ADDENDUM NO. 1

ISSUE DATE: April 2, 2020

DAWSON FOREST WRF SLUDGE DEWATERING UPGRADES

ETOWAH WATER & SEWER AUTHORITY
DAWSONVILLE, GEORGIA

**SKETCH
NO. C.04-1**

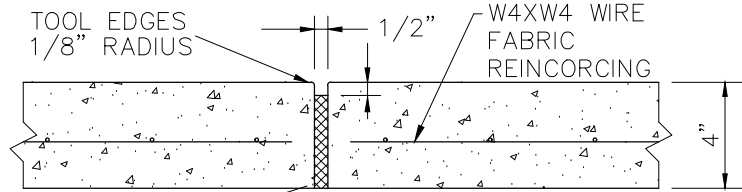
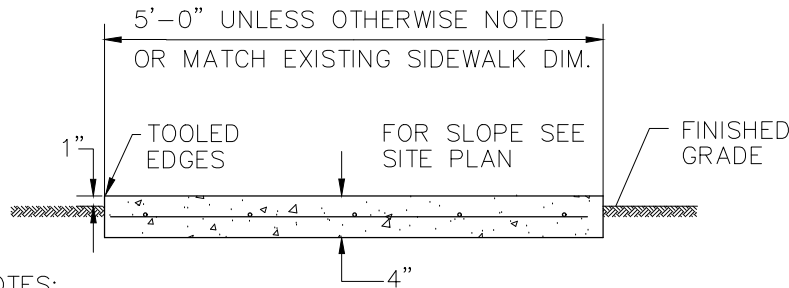
2. **Drawing C.04: ADD the “TYPICAL SIDEWALK DETAIL” to Drawing C.04 as shown in the attached Sketch C.04-1.**
3. **Drawing ESC.04: REPLACE this sheet with the attached revised Drawing ESC.04.**

1. PROVIDE 1" DEEP CONTROL JOINT ACROSS CONCRETE AT 5' C.C.
2. MAXIMUM CROSS SLOPE 1:10
3. PROVIDE EXPANSION JOINT ACROSS CONCRETE AT 25' C.C.
4. PROVIDE EXPANSION JOINT BETWEEN SIDEWALK AND ALL STRUCTURES
5. MINIMUM REINFORCING SHALL BE WELDED WIRE FABRIC (W4XW4)

TYPICAL SIDEWALK DETAIL

SHEET
M.03-1

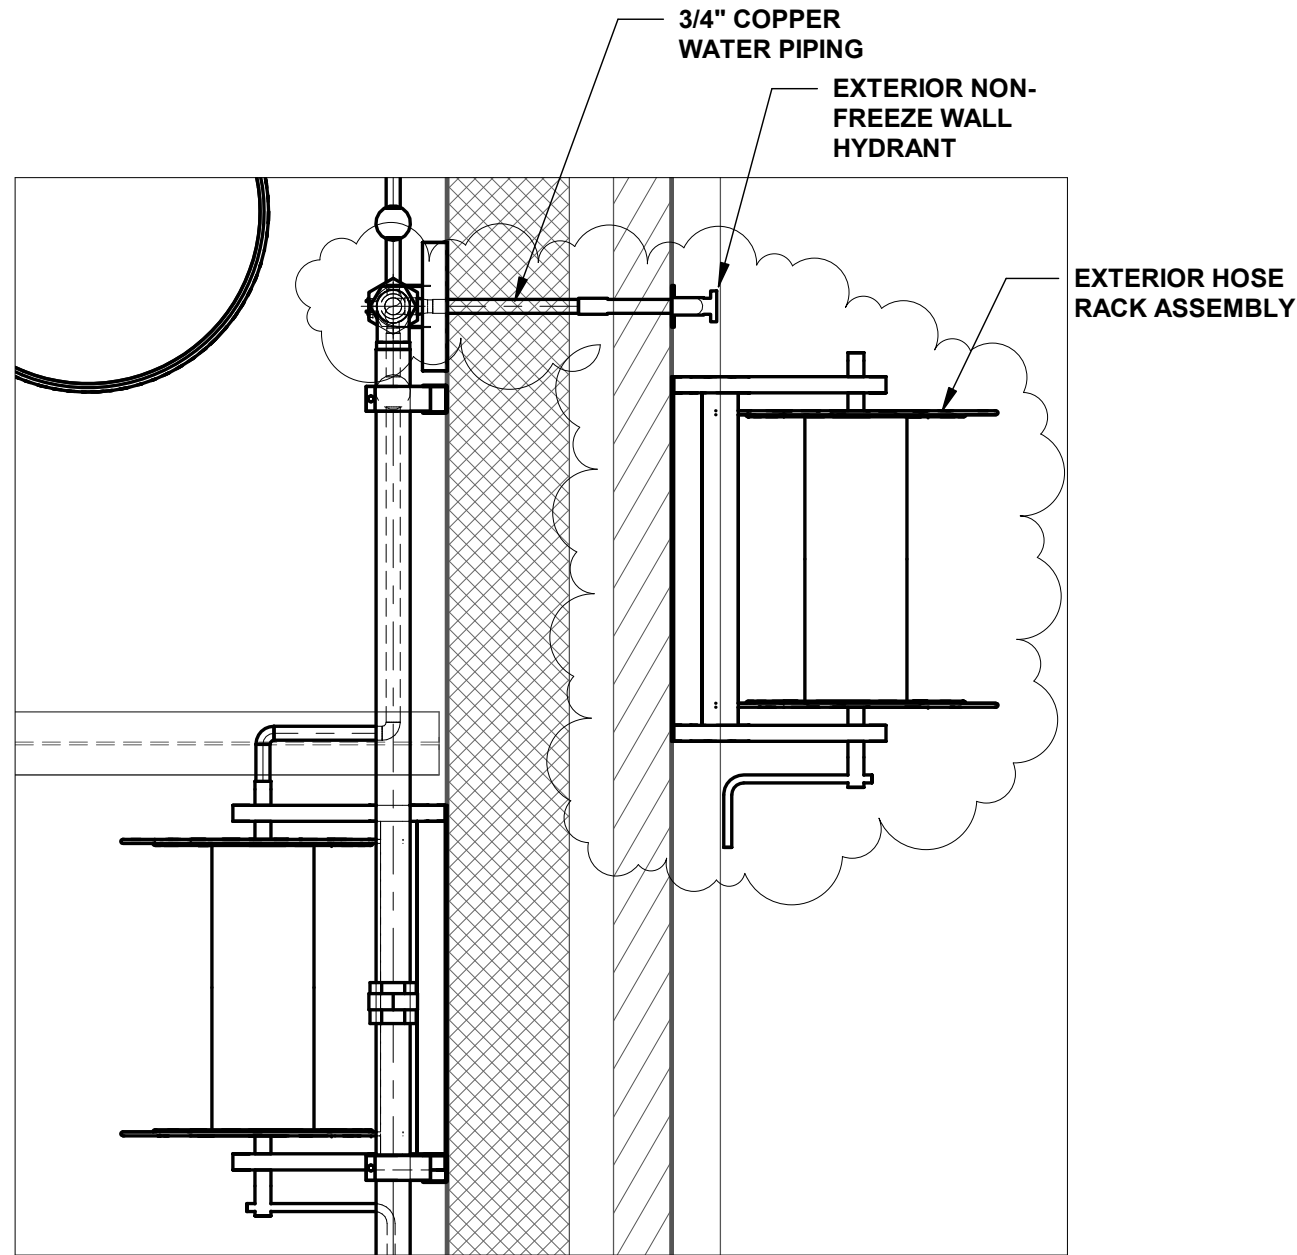
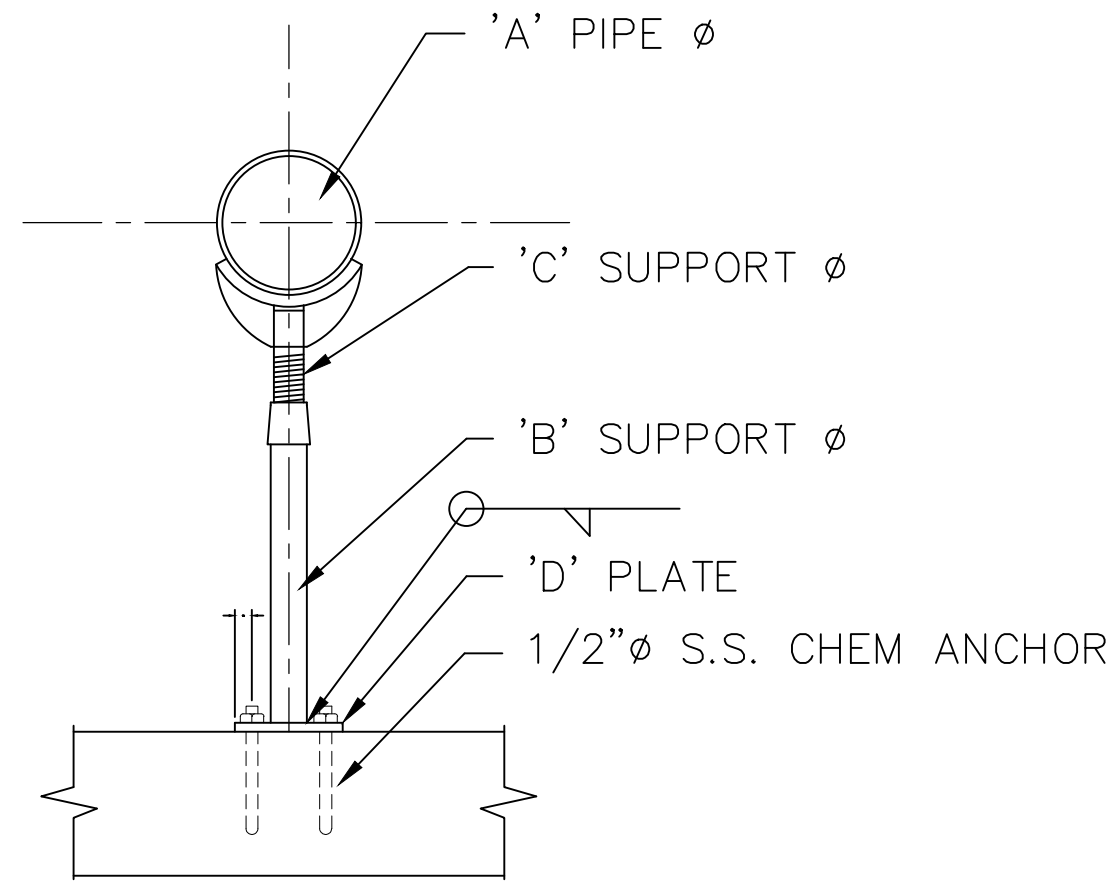
4. **Drawing M.03: MODIFY the water piping routed to the “EXTERIOR HOSE RACK ASSEMBLY” as shown in the attached Sketch M.03-1; adjust “EXTERIOR HOSE RACK ASSEMBLY” location as shown.**

1 DETAIL AT EXTERIOR HOSE RACK
1" = 1'-0"

P.S.#12 P.S.#5 TYPICAL BASE BEND SUPPORT
N.T.S.

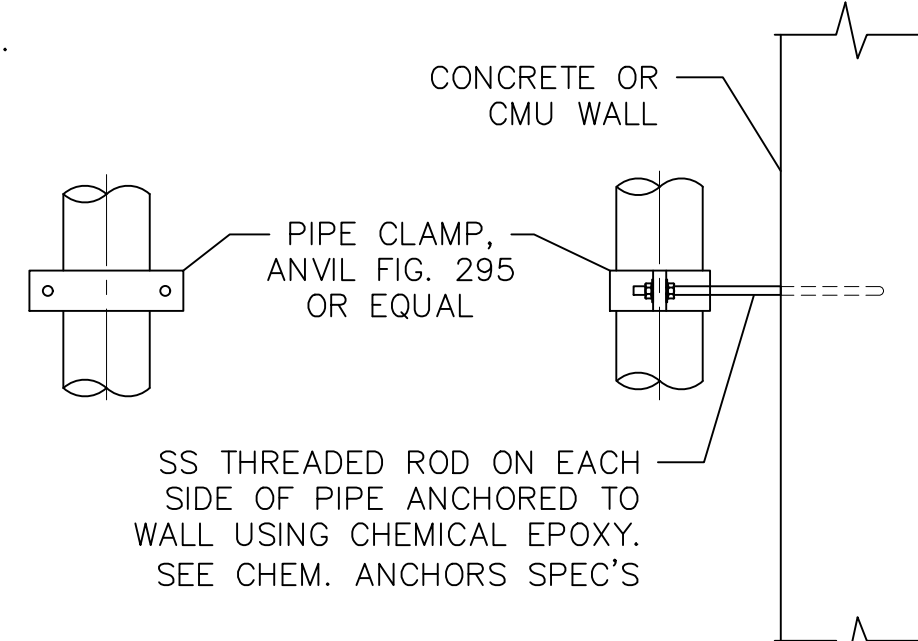
Question #	Question	Answer
15	Is the magmeter shown on sheet E.03 going to be provided by Charter Machine? If not, can you provide a spec on the magmeter.	No, the required 6" Magnetic Flow Meter shall be furnished and installed by the Contractor. This will be clarified in Addendum No. 1, including details on the meter to be provided.
16	Please clarify what piping gets heat trace and insulation. If this is shown on the drawings we can't find anything, other than a note on sheet E.03 (near the dumpsters).	This note will be deleted in Addendum No. 1. No heat tracing and insulation is needed in this area.
17	There is a spec section on "Sewer and Manhole Testing " and "Manhole and Structures". Are there any manhole structures to be provided?	The required precast manhole structures are currently being installed by others. Therefore, these spec sections will be deleted in Addendum No. 1.
18	In regards to pipe supports, there is a pipe support P.S. #8 (wall bracket) shown on sheet M.03 but there is no Detail for P.S. No. 8 shown on sheet M.08 (there is a Detail P.S. #6 wall bracket on sheet M.08). Same applies to a pipe support P.S. #12...shown on sheet M.03 but no Detail P.S. #12 on sheet M.08.	This will be clarified in Addendum No. 1.
